COMBS PLACE SUBDIVISION,
RESUBDIVISION OF LOT 2

APPLICATION NUMBER 1 DATE April 16, 2009

REQUEST Subdivision

DETAIL SITE PLAN

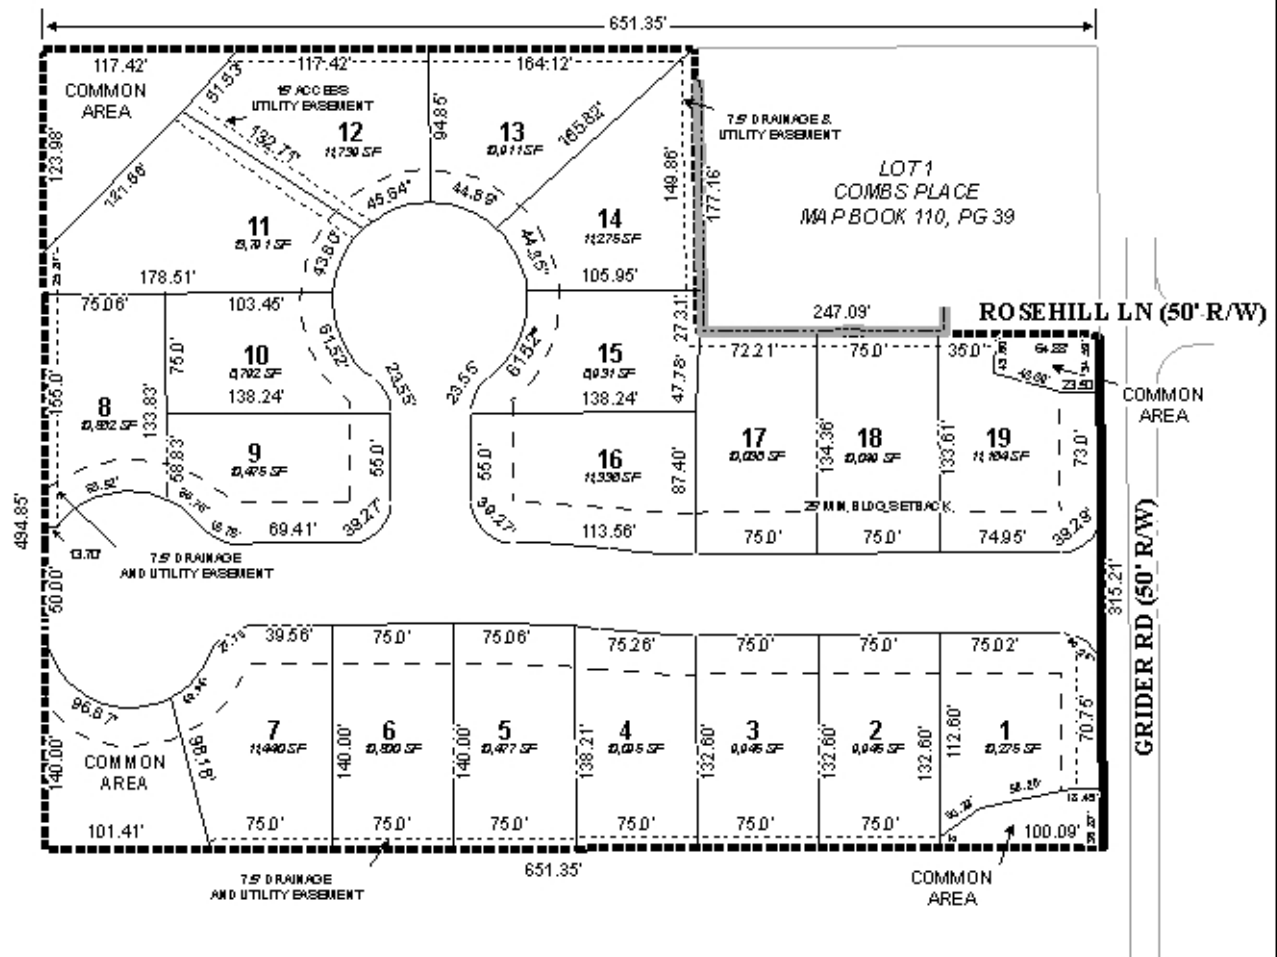
As proposed, the subdivision will create twenty (20) lots, with a minimum lot size of 8,385 square feet. A cul-de-sac and street stub are depicted on the plat, as are four common areas. While no provision is made for the necessary dedication of right-of-way along Grider Road, the layout otherwise meets all of the requirements of the Subdivision Regulations.

The revised plat depicts the proposed 19-lot subdivision, with a minimum lot size of 8,792 square feet and a maximum lot size of 13,791 square feet. One lot was removed to provide additional space for common area (storm water detention) and to allow for a cul-de-sac at the western end of the development to accommodate 2003 International Fire Code requirements.

The applicant states that construction of the proposed 19-lot subdivision would make it financially feasible for the applicant to make improvements to Grider Road to the site to provide a 20-foot pavement width with 6-foot shoulders on each side, with the road retaining an open-ditch cross-section. The applicant's road improvements will only extend to the northern-most portion of the development site, leaving approximately 500-feet of Grider Road in its current state. Section V.B.15. of the Subdivision Regulations states that a minor street shall have a pavement width of 26 feet. Appendix D of the 2003 International Fire Code, as adopted by the City of Mobile, states that dead-end "fire apparatus access" roads greater than 501 feet shall have a minimum width of 26 feet. City Engineering standards require 23 feet of pavement width plus curb and gutter. Even the private street standards of the Subdivision Regulations requires a minimum pavement width of 18 feet with two 2-foot wings, for a total width of 22 feet.

As previously mentioned by staff, Section V.B.14. of the Subdivision Regulations states that roads lacking curb and gutter shall have a right-of-way width of 60 feet, however, the subdivision does not provide dedication along Grider Road as would typically be required.

The subdivision site is on a hilltop, and the additional information provided by the applicant shows that adequate slope may be available to allow the proposed development to connect with the existing sewer service in Summer Place Subdivision. No information was provided from an engineer or MAWSS, however, indicating if the existing sewer service has adequate capacity to serve the proposed development.

- 1) The subdivision would result in lot sizes uncharacteristic to the immediate vicinity, per section V.D.1. of the Subdivision Regulations; and*
- 2) Grider Road is a substandard road, even with the proposed improvements, and cannot accommodate additional traffic until it is improved to City standards, thus it does not meet the accessibility requirements of Section I.B.2. of the Subdivision Regulations.*
